TRIANGLE SPRING®

Sales Bulletin

February 1, 2005

Freightliner Spring Additions

FREIGHTLINER AIR LINER II

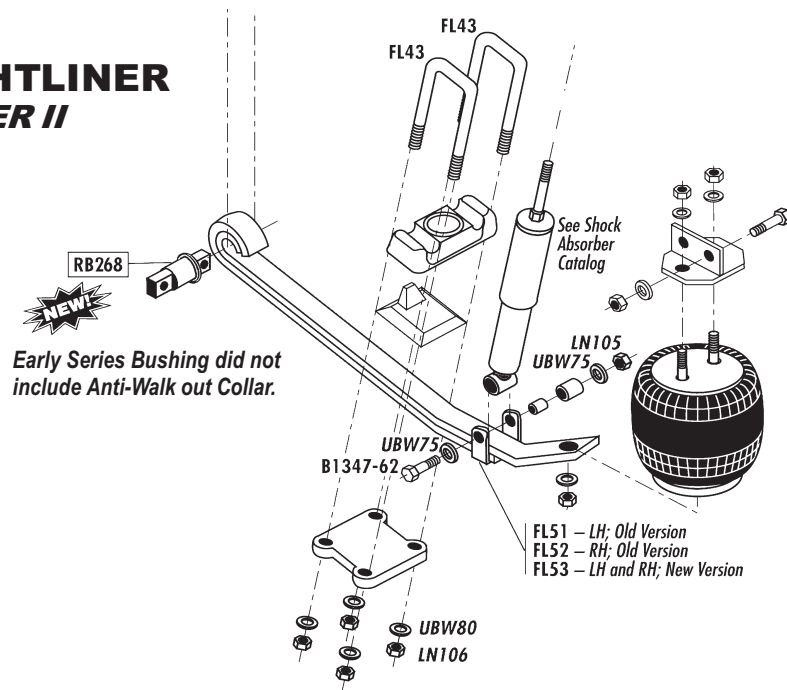
Most of you are aware that Freightliner Corp., on their Airliner II Air Suspension, changed the eye bushing to an RB268, which is a directional bushing. This does not pose a problem on the springs with Hardaway bends that can only be installed one way. However, the suspension which has the 46-1217 spring is straight, and in the past would fit either side. With the new bushing there are now two part numbers:

A16-16414-000 - 46-1349 Left Hand

A16-16414-001 - 46-1351 Right Hand

When ordering in the future you will need to determine from your customer whether it is a right or left. The two springs are no longer interchangeable.
